# CAIRNGORMS NATIONAL PARK AUTHORITY

**Title: CONSULTATION RESPONSE TO PLANNING APPLICATION TO ABERDEENSHIRE COUNCIL ON SITE OUTSIDE OF PARK BOUNDARY**

**DEVELOPMENT PROPOSED: FORMATION OF WINDFARM COMPRISING 18 TURBINES AND ASSOCIATED INFRASTRUCTURE CLASHINDARROCH FOREST, NEAR HUNTLY, ABERDEENSHIRE**

**APPLICANT: VATENFALL WIND POWER LIMITED**

**Figure 3 Map showing current wind farm consents/application/pre application around Park boundary.**

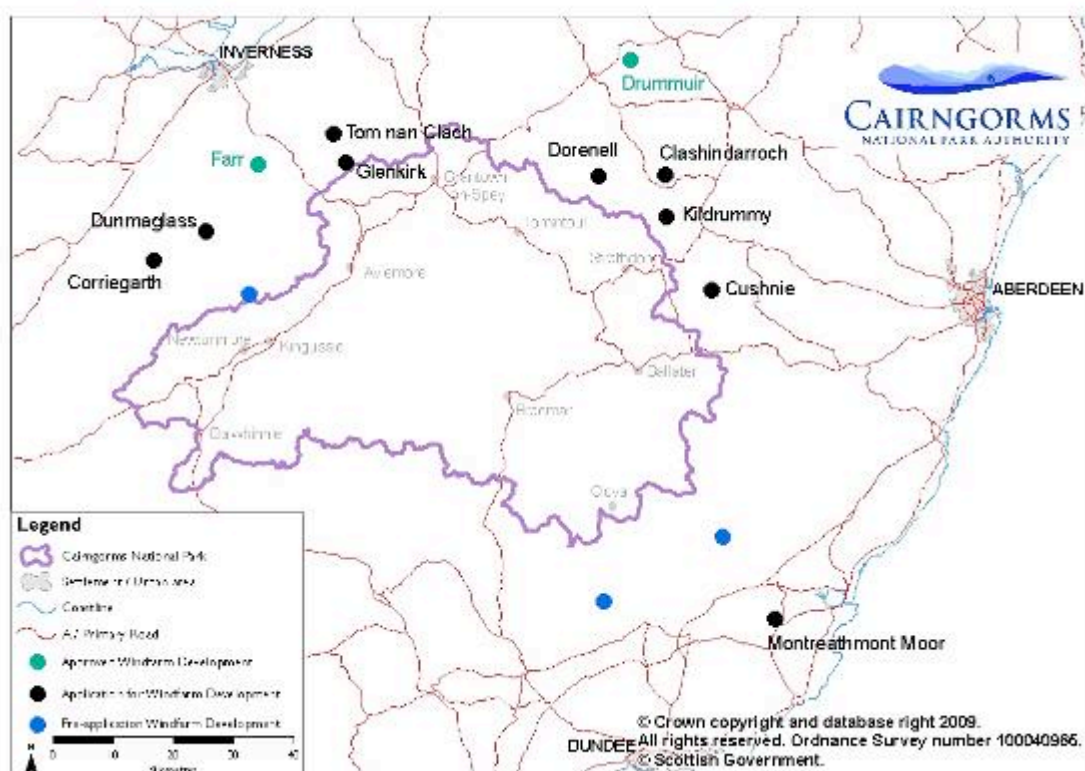
38. The conclusion of the ES with regard to the Park considers that the effect of existing/proposed wind farms on the Park overall would be minor/moderate and not significant. Consequently, the applicant's consider that the wind farm would not detract from the quality or character of the National Park overall. It may be the case that all existing/proposed schemes would not threaten the overall integrity of the Park. However, this does not mean that the cumulative effects of schemes would not have a negative effect upon some parts of the Park. Since the Reporter's refusal of the 37 turbine application, schemes at Dorenell, Moray (59 turbines) and Cushnie, Aberdeenshire (7 turbines) have been submitted as formal applications (see fig 3). Both developments would be visible from the Ladder Hills although in different directions from the Clashindarroch and Kildrummy sites.

The CNPA objected to both of these applications. I am of the view that, if Cushnie and Dorenell received approval then there would be detrimental impacts upon the part of the Park covering the Ladder Hills. While Clashindarroch on its own is considered acceptable its combination with the recently approved Kildrummy causes some concern with regard to cumulative landscape and visual impact. However, on the advice of our Landscape Officer I am not of the view that this would warrant an outright objection. However, if both Kildrummy and Clashindarroch were joined by the 59 turbine scheme at Dorenell there would be cumulative impacts of serious concern.

**A) While not objecting to this proposal the CNPA would raise concern that if wind farms at Dorenell and Cushnie received permission and were constructed in addition to Kildrummy and Clashindarroch the resulting combination would cause detrimental cumulative visual impacts on the north eastern boundary of the Park and in particular the Ladder Hills. Consequently, this would impair the enjoyment of those residents of and visitors to the Park taking part in recreation and traditional sporting activities in the Ladder Hills area. Any scenario involving the potential addition of Dorenell and/or Cushnie to Clashindarroch and Kildrummy would be considered to have unacceptable impacts upon the first aim of the Park to conserve and enhance the natural and cultural heritage of the area.**
